Docket Number:	22-BSTD-01
Project Title:	2025 Energy Code Pre-Rulemaking
TN #:	252138
Document Title:	FLUIDRA Comments - Comments for Docket 22-BSTD-01 2025 Energy Code Pre-Rulemaking
Description:	N/A
Filer:	System
Organization:	FLUIDRA
Submitter Role:	Other Interested Person
Submission Date:	9/5/2023 5:09:43 PM
Docketed Date:	9/6/2023

Comments for Docket 22-BSTD-01 2025 Energy Code Pre-Rulemaking

Re: Request for comment and Pre-Rulemaking Title 24 2025, Solar Swimming Pool and Spa Heating, Docket # 22-BSTD-01, **UPDATED August 16, 2023**

Typical Solar collector plumbing kit available in market

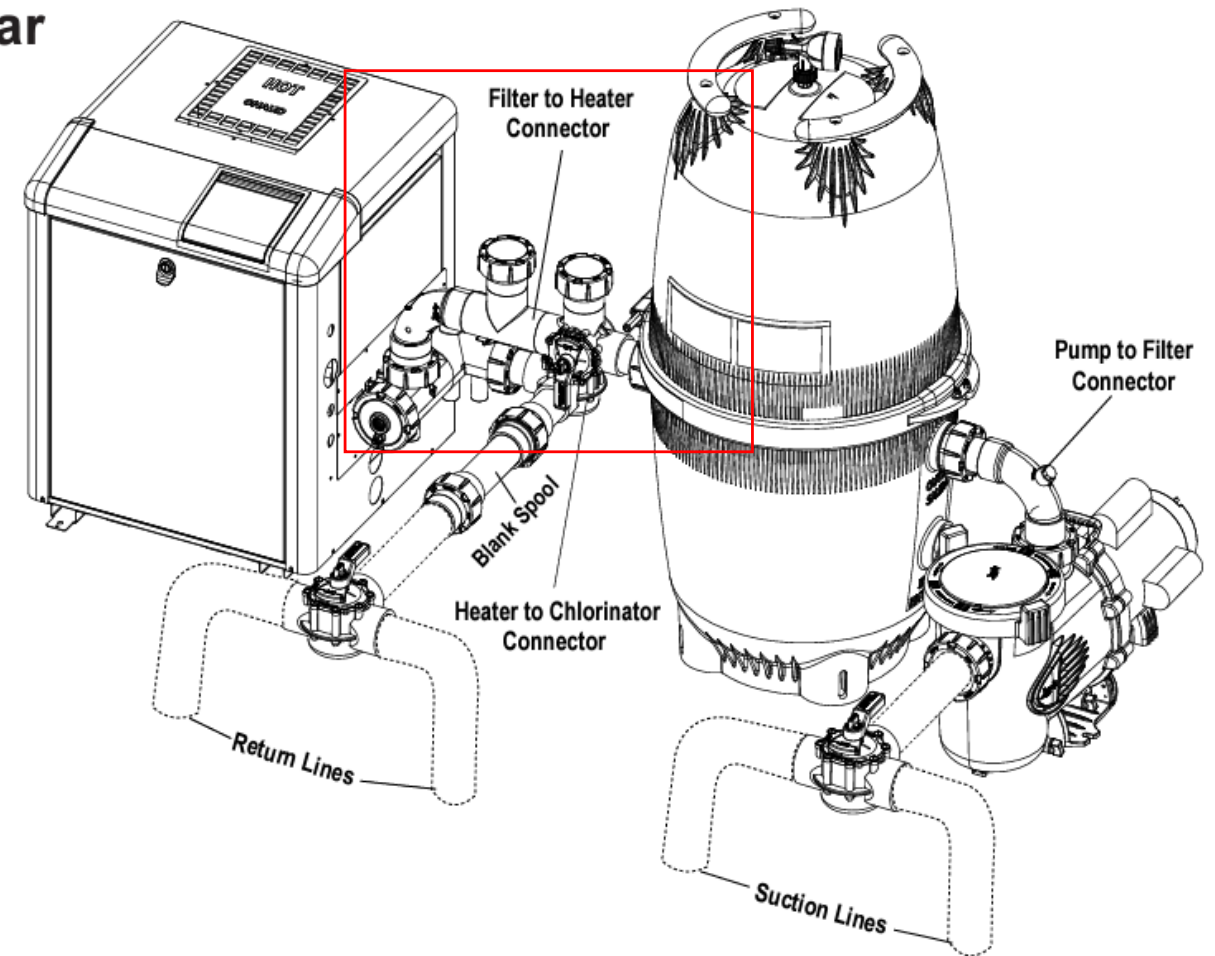
There is often very limited space on a pool pad to set all pool equipment. 36 Inches of piping would be an unnecessarily inordinate amount for solar heating plumbing connections. Attached is a drawing for a standard solar plumbing kit that is available in the marketplace that accommodates 2" and 2.5" plumbing which can easily be installed with the suggested 18 inches of

plumbing. Additionally, this is in harmony with the national ANSI/APSP/ICC-15 standard for energy efficiency.

2. **Piping.** At least ~~36~~ 18 inches of pipe shall be installed between the filter and the heater or dedicated suction and return lines, or built-in or built-up connections shall be installed to allow for the future addition of solar heating equipment.
